Fort Bend LID 19 – Phase 3 Recommendations

June 3, 2019

## 1.0 EXECUTIVE SUMMARY

**Re:** The Grove at Riverstone Drainage Model Revisions and Modification -- APTIM

**Figure 5.1 Supplemental Pump Station Location**

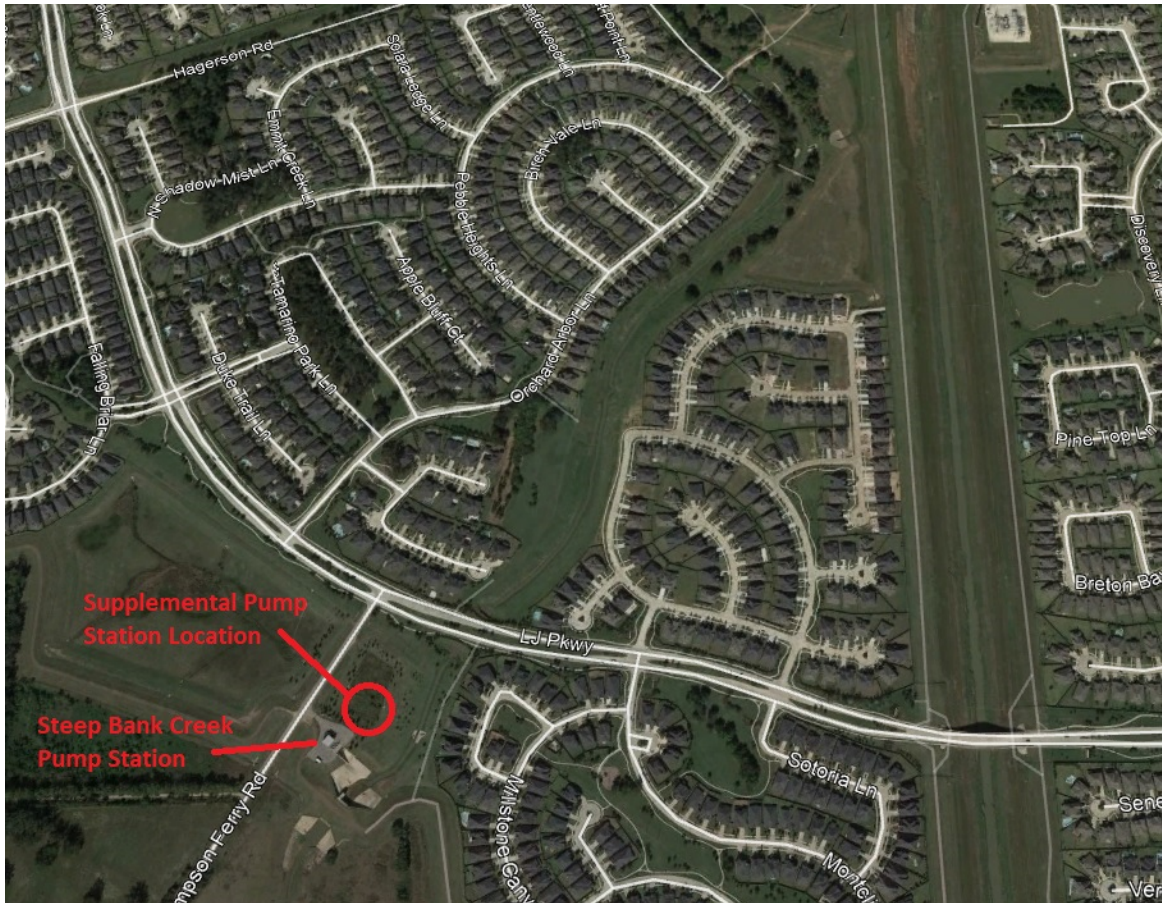
To achieve the increased pumping needs under the TP40 results, and to provide minimal disruptions to the existing pump station, a new supplemental pump station is being proposed just north of the existing Steep Bank Creek pump station, as shown in Figure 5.1, utilizing the same outfall as the Steep Bank Creek pump station. The conceptual configuration of the supplemental pump station includes three (3) 30,000GPM pumps. The third 30,000GPM pump is required to satisfy the FBCDCM criteria of having a spare of the largest pump in case one is out of service. The result is a total pumping capacity of 140,000GPM + 30,000GPM, or 170,000GPM at Steep Bank Creek. These additions would meet the current criteria utilizing TP40 rain data. Refer to Table 6.1 Summary of Design Storm Analyses and Pumping Capacities.

Using the Atlas 14 results, a new supplemental pump station just north of the existing pump station would still be proposed, but with a different configuration. The conceptual pump configuration includes three (3) 40,000GPM pumps. The third 40,000GPM pump is to satisfy the FBCDCM criteria of having a spare of the largest pump. The new pumping capacity would then be 160,000GPM + 40,000GPM for a total of 200,000GPM at Steep Bank Creek. Refer to Table 6.1 Summary of Design Storm Analyses and Pumping Capacities.

**Figure 1.1 Aerial (a) and Field Photographs (b) at Culvert Link: 8-9-LEVE**

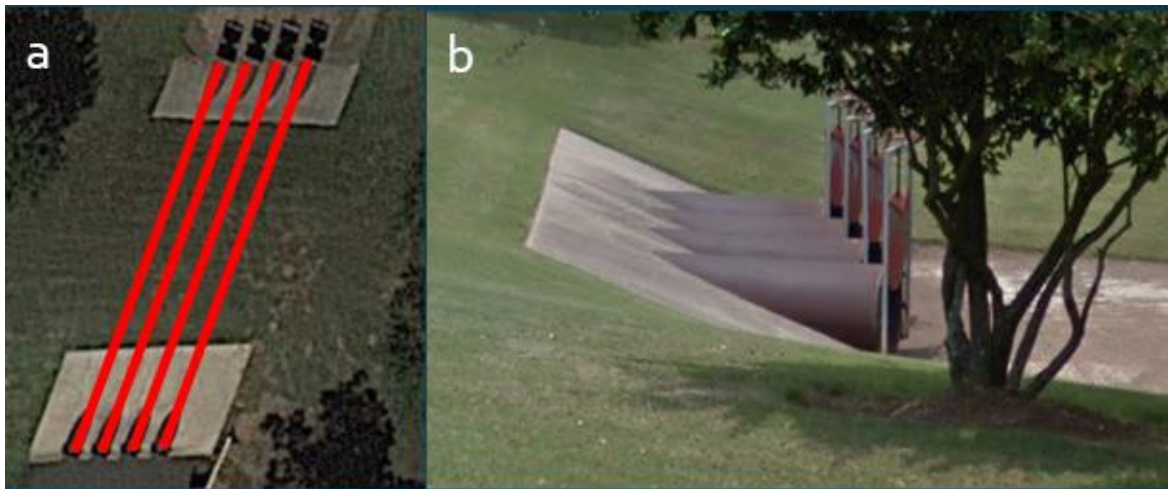
- 1.3 Entrance Loss Coefficients:** A significant number of entrance loss coefficients in the original model were not consistent with the assigned FHWA inlet edge descriptions and end treatments observed in the field or from aerial photography. SAI updated the pipe entrance loss coefficients using field photographs provided by APTIM, aerial mapping and plans. **Figure 1.1** shows an example of one such location. Culvert **Link: 8-9-LEVE**

includes mitered end sections. The original model had an entrance loss coefficient value set to 0.5, however, a value of 0.7 is more appropriate, as well as which is used for updating entrance loss. In addition, it was noted that most channels in the original model included a value of 0.5 for the entrance loss coefficient. Channels do not normally include entrance losses, unless an unusual situation is encountered which warrants additional hydraulic losses (e.g., aerial crossings, etc.). SAI reviewed all channels and reset entrance loss coefficients to 0.0. A total of 24 pipes and 38 channel entrance loss coefficients were revised with changes ranging from +/- 0.1 to 0.5. **Impacts from these changes will vary from location to location, depending upon the specific change.**

### Figure 1.2: Correction to Offline Storage / Channel Cross Section

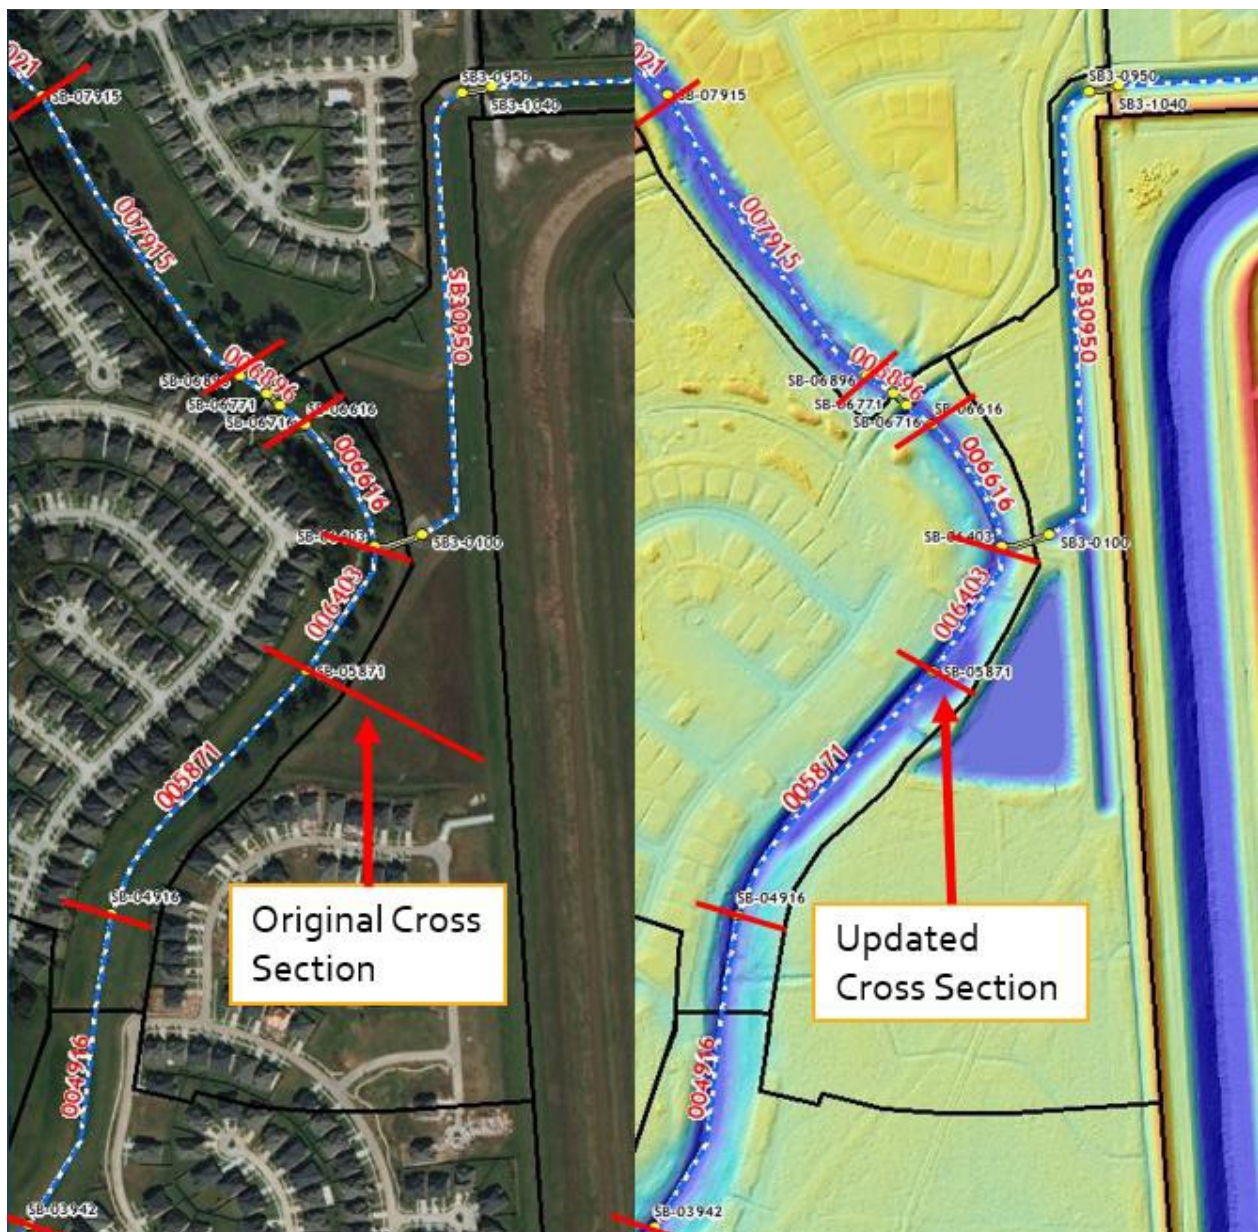
**Figure 1.2** shows a conflict between a ditch cross section and an adjacent basin boundary and storage area. Storage in the basin adjacent to channel was originally approximated with the channel cross section and included in SB3-0100; This approach inaccurately included the pond area as effective flow area through its inclusion in the section in addition to “double counting” the storage. This problem was addressed by revising the channel

cross section . **Figure 1.3** compares the original cross section and updated cross section for this location.

**Figure 1.4 Subbasin Boundary Adjustments**

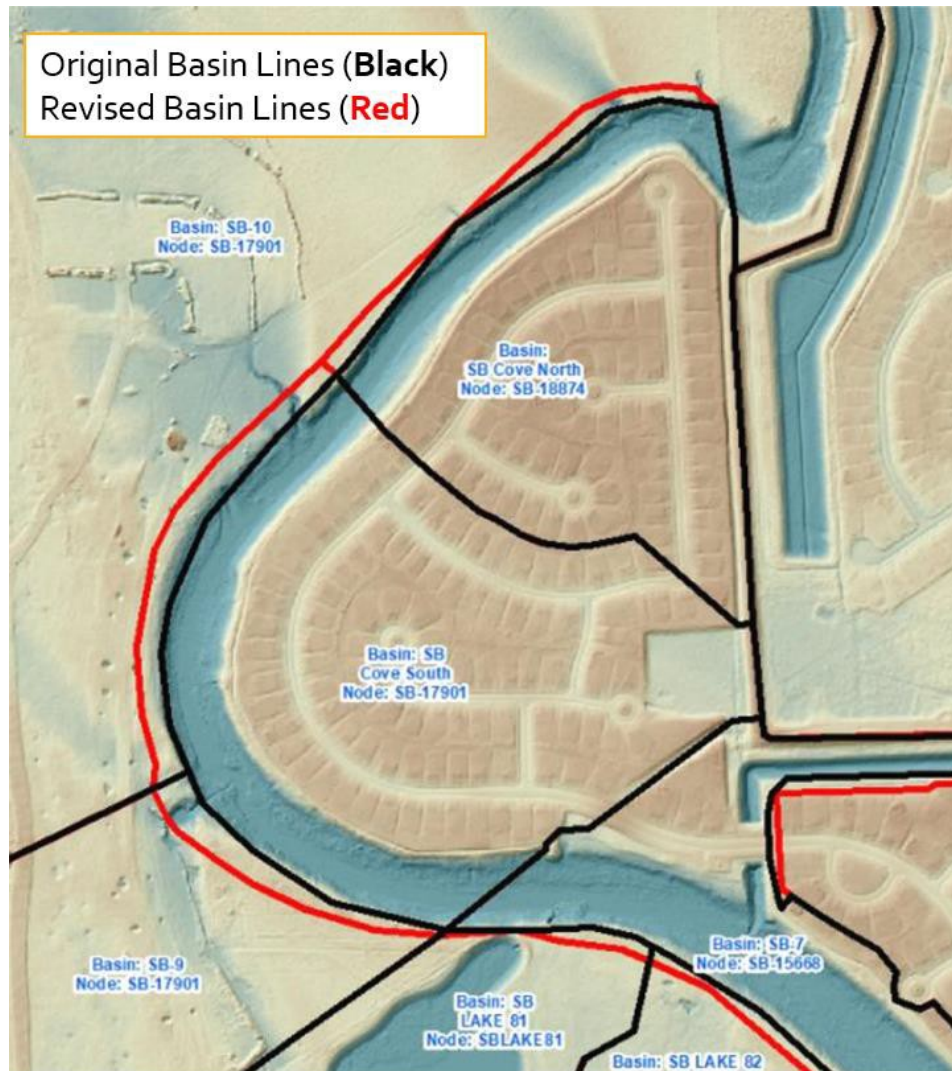
- 1.7 Subbasin Boundary Adjustment:** Some subbasin boundaries associated with the original model were noted to include areas within the ditch system (i.e., on the ditch sidebank). These were revised to follow the DEM and avoid overlaps between the pond and channel control volumes. [Figure 1.4](#) shows an example one revision. It should be mentioned that the subbasin boundary changes were minor and did not have significant effects on basin area and runoff calculations.
